## Architectural Review Board Staff Report

**Project type:** Amended Architectural Elevations

**Description:** **Chesterfield Commons, Outlot 10 (Red Lobster)**: Amended Architectural Elevations for a restaurant building on a 1.72 acre tract of land, zoned "C8" Planned Commercial District located south of Chesterfield Airport Road and west of JW Drive(17T130133).

**Proposed Amended Architectural Elevations**

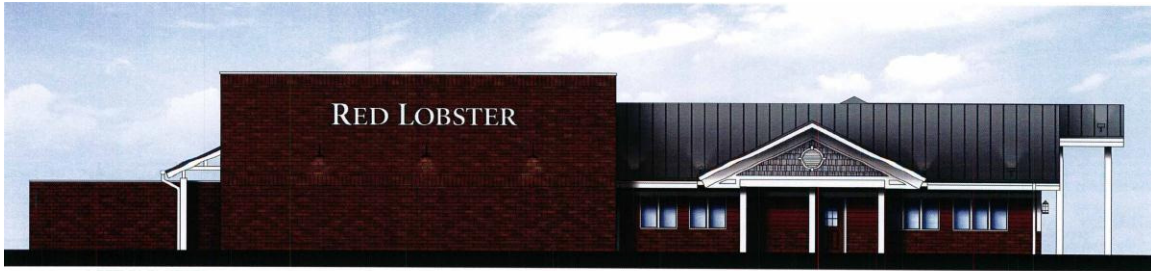
The applicants request to change the color of the hardie plank siding from blue to burgundy and to paint white the unpainted wooded supports for the gabled entry. The applicants also wish to enclose the existing entry gables with wooden shingles. The applicant further wishes to remove the existing damaged metal shutters along the sides of the building.

The applicant has requested to add a number of light fixtures to the roof of the existing structure. Although these lighting fixtures are considered to be architectural, they must be aligned so as to not project light above the roofline of the existing structure.
